DISPUTE REVIEW BOARD RECOMMENDATION

State Rd. 951, Collier County
FN 195320-1-52-01
FAP No. 3251-006-P
District 1
DRB Issue No. 2

**Re: State Project No. 03030-3509
SR 951 from Marco Island Bridge to South of New York Drive, Collier County
Top Down Bridge Construction – Issue No. 2**

Sheet 76, Traffic Control Plan - Phase I of the Project Plans shows that traffic will be maintained on the existing bridge during Phase I:

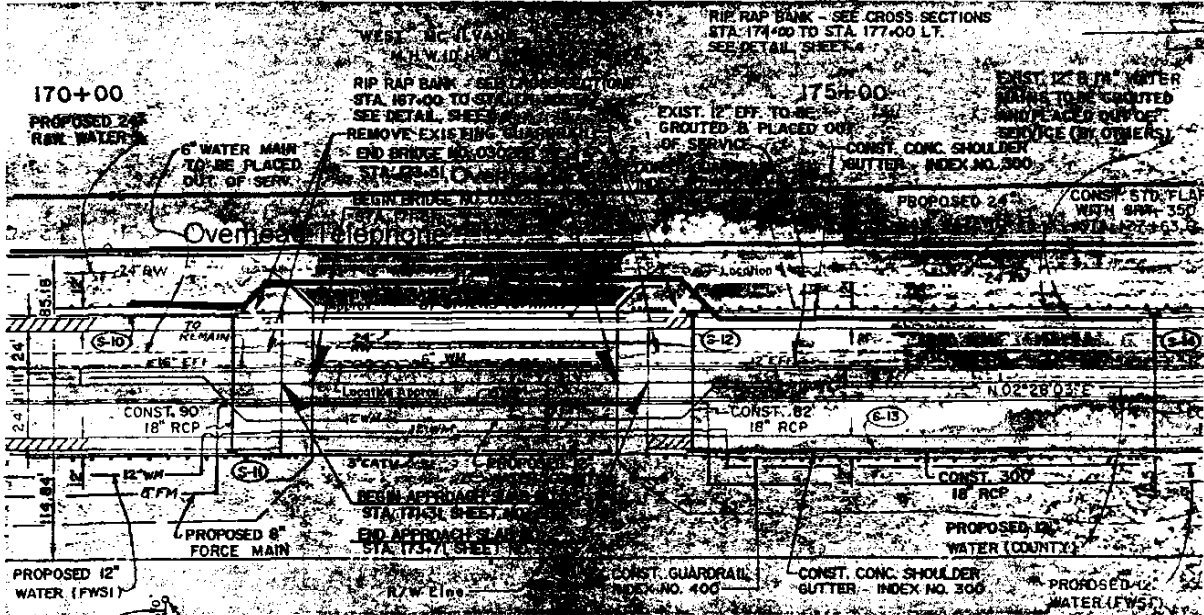
PHASE I
 MAINTAIN TWO-WAY TRAFFIC ON EXISTING ROAD
 WHILE CONSTRUCTING NEW PAVEMENT
 AND MEDIAN CURBS IN AREAS INDICATED BY: 
 CONSTRUCT TEMPORARY PAVEMENT:

Photos taken on the project by the DRB show the relative position of the FWS line in question.

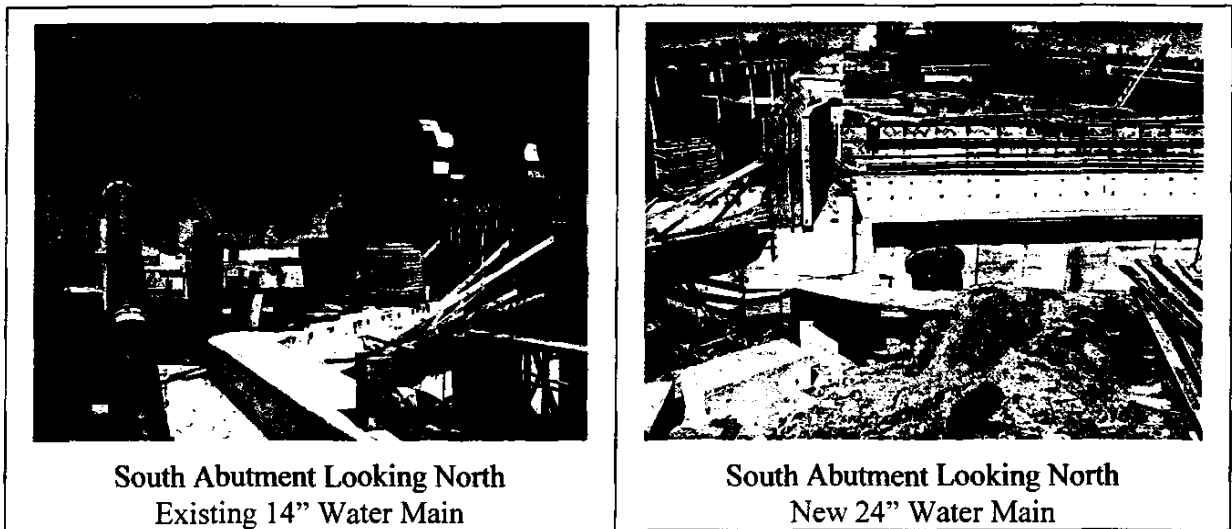
South Abutment Looking North
Existing 14" Water Main

South Abutment Looking North
New 24" Water Main

GCI's argument that the removal of the 14" line falls within the scope of 110-1 Clearing & Grubbing is not applicable. However, since the 14" waterline was to be grouted and placed out of service it would be reasonable for a bidder to come to the conclusion that the existing aerial portion of this line could be removed for access to the site (albeit it might be at his expense). However, it would be incumbent upon the bidder to confirm this conclusion with the affected utility owner.

Even if the 14" aerial waterline had been removed, the Contractor would have had to contend with constructing the western portion of the bridge in a confined area restricted by the proposed 24" waterline and supports on one side and the overhead telephone, CATV and overhead electric on the other.
